**OHIO TURNPIKE COMMISSION**

**ADDENDUM NO. 2**

**CONTRACT NO. 53-12-02**

**SERVICE PLAZA RENOVATIONS, ERIE ISLANDS & COMMODORE PERRY,  
MILEPOST 100, SANDUSKY COUNTY, OHIO**

## Dimensions

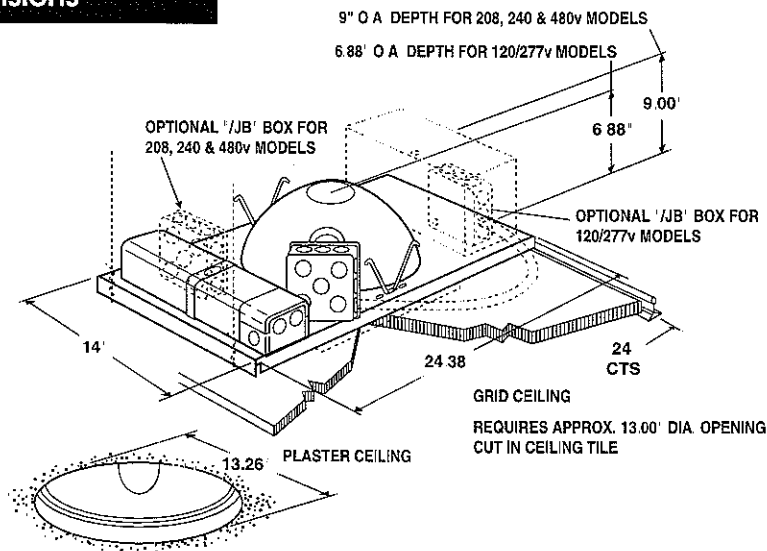
**Q#11** Electrical question for the Service Plaza Renovations at the Erie Island and Commodore Perry Service Plazas, 53-12-02. What are the fixture specifications for the exterior canopy fixtures? Drawing E.01 indicates that the exterior canopy recessed fixtures at the fueling areas are to have the trims replaced. The note on the drawing calls for these fixtures to be "Guth Selux Metal Halide recessed round down-lights", this trim description cannot be found. These trims cannot be priced if a specific type is not given to the lighting representative. Will you issue an allowance dollar value per trim so all electrical bids are competitive? I did not take a picture of the fixture, this may help identify the fixture if you able to send a pic.

*A#11 The intent of the Plans is to replace exterior fixture trims for the recessed soffit or "down lights" as shown in the Contract Documents. The existing down light fixture is a Guth Lighting "SEELUX" fixture, catalog number B115. This is a nominal twelve (12) inch, metal halide down light. A cut-sheet for the fixture is attached to this Addendum.*
